Project	IEEE 802.16 Broadband Wireless Access Working Group < http://ieee802.org/16 >	
Title	Changes to the Sections 15.3.2, 15.3.2.1, 15.3.2.2, & 15.3.2.3 re:Coexistence Messaging Mechanism	
Date Submitted	2007-01-08	
Source(s)	John Sydor Communications Research Centre 3701 Carling Avenue Ottawa, Ontario	Voice: 613-998-2388 Fax: [Fax Number] john.sydor@crc.ca
Re:	Changes to Draft Standard	
Abstract	Editorial changes to provide clarity and change terms common to draft standard	
Purpose	Add consistency and clarity to draft document.	
Notice	This document has been prepared to assist IEEE 802.16. It is offered as a basis for discussion and is not binding on the contributing individual(s) or organization(s). The material in this document is subject to change in form and content after further study. The contributor(s) reserve(s) the right to add, amend or withdraw material contained herein.	
Release	The contributor grants a free, irrevocable license to the IEEE to incorporate material contained in this contribution, and any modifications thereof, in the creation of an IEEE Standards publication; to copyright in the IEEE's name any IEEE Standards publication even though it may include po

Figure h35 ~~CCD~~ [Candidate Channel Determination Process](#)

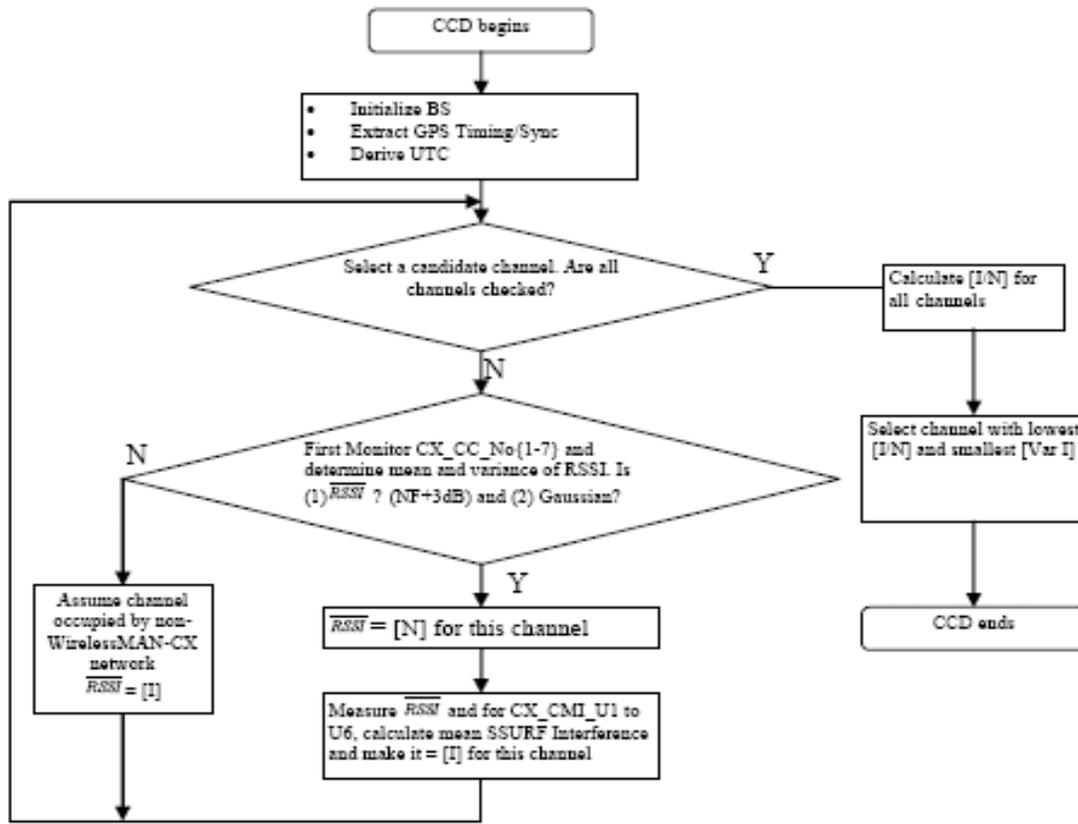
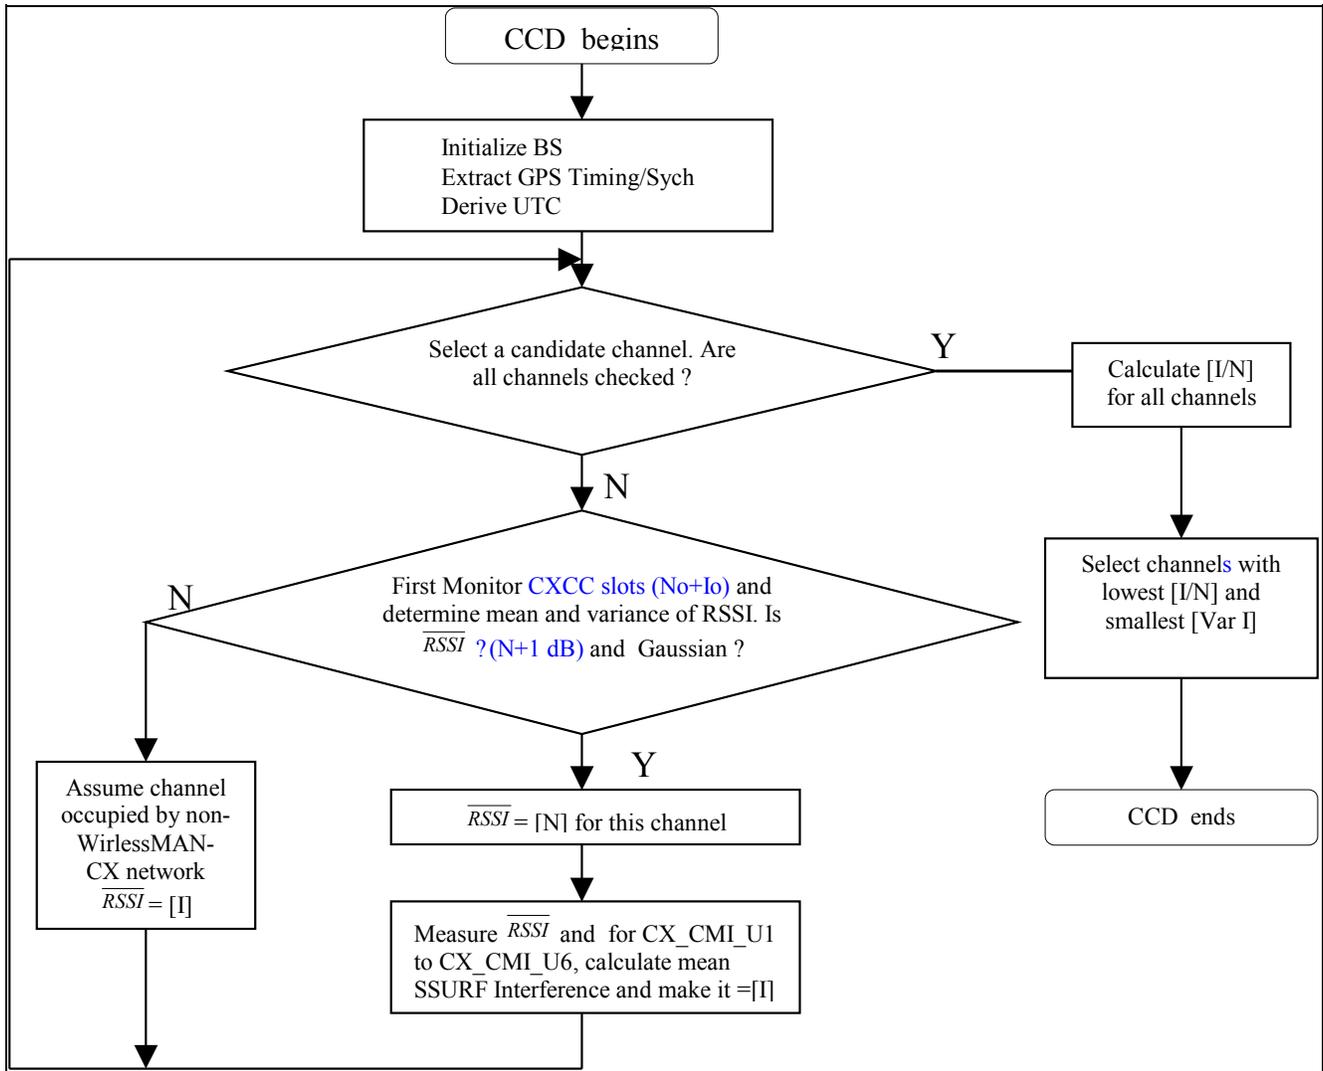
Delete the following figure h35 found between lines 1 and 36 of page 75 of [1]

*Replace the figure h35 deleted above with the following figure. The markings in **Blue** represent the changes between the above figure and the new figure below.*

Figure h36 CMI Identification and Claiming and IBS Community Entry Process Using CMI Signaling on the CXCC

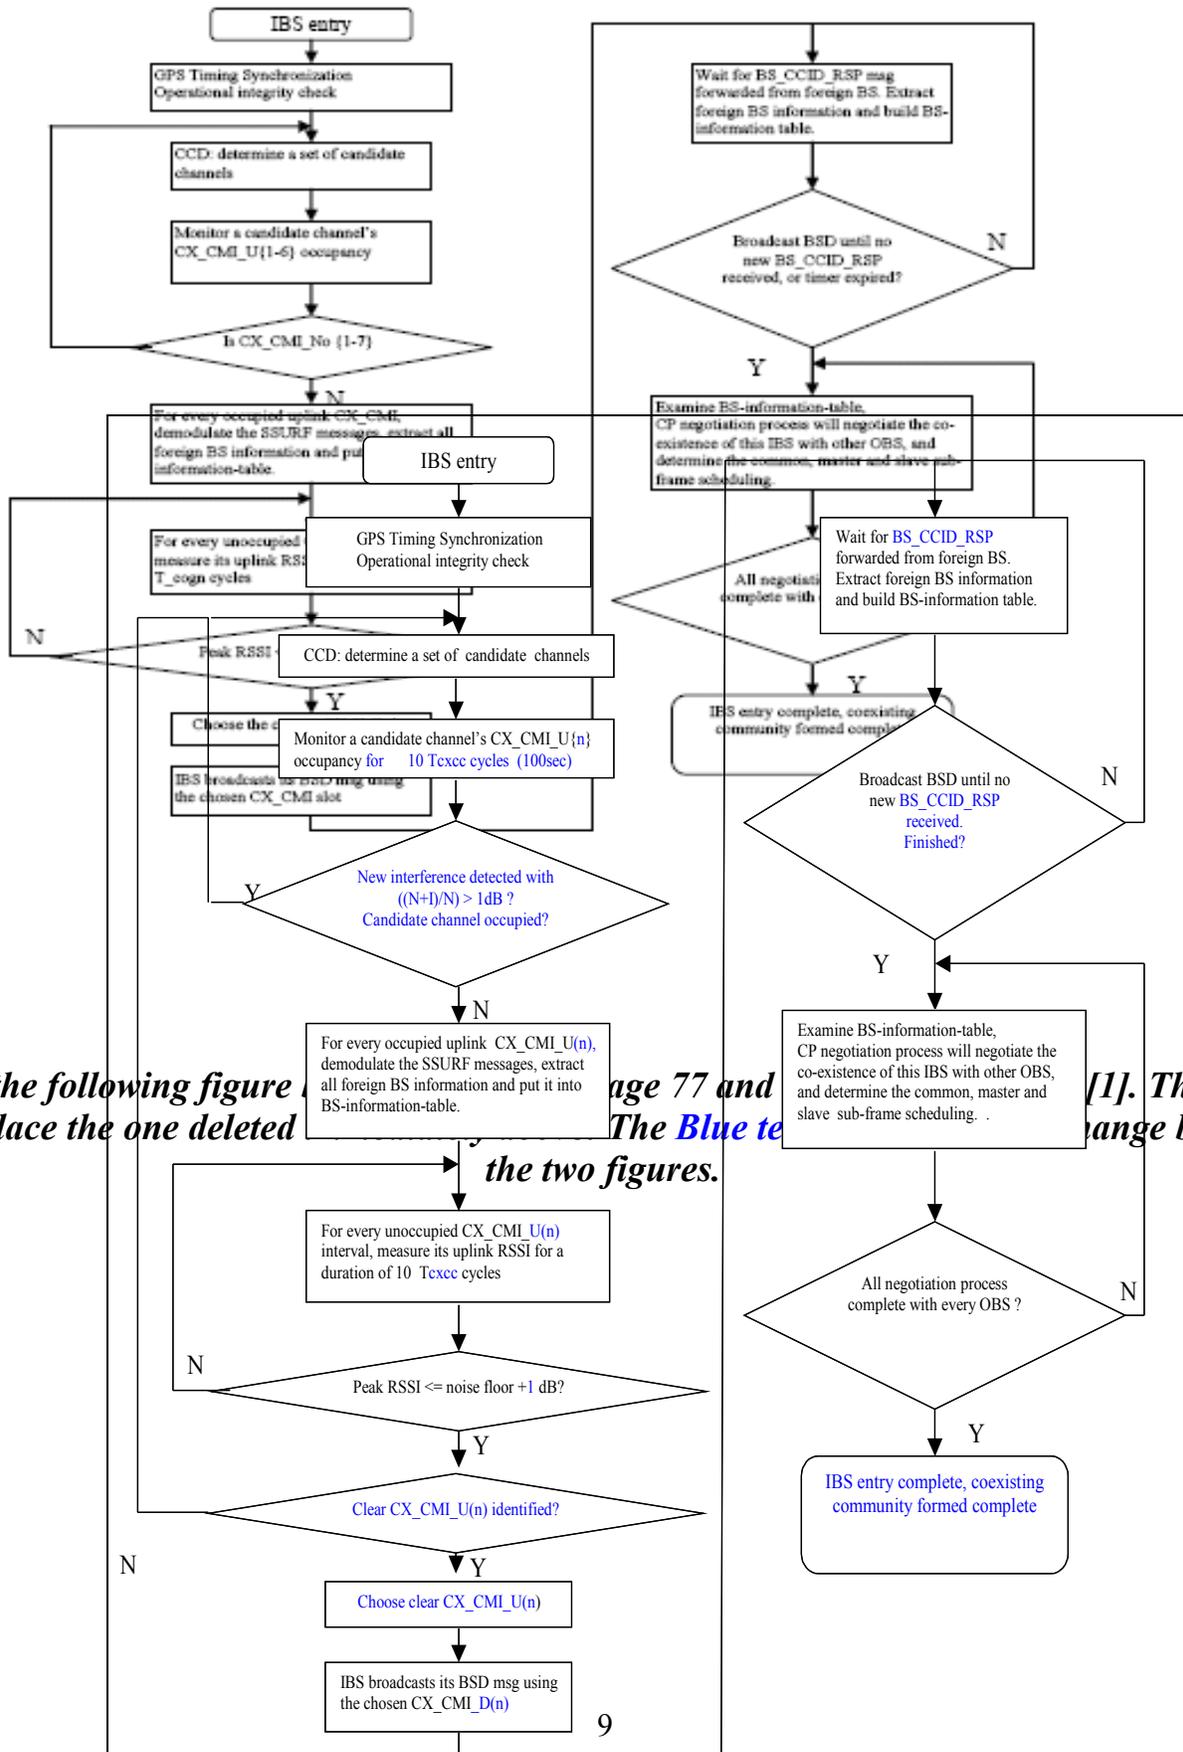
Delete the following figure h36 currently found between line 30 of page 77 and line 2 of page 78 of [1].

Insert the following figure to replace the one deleted
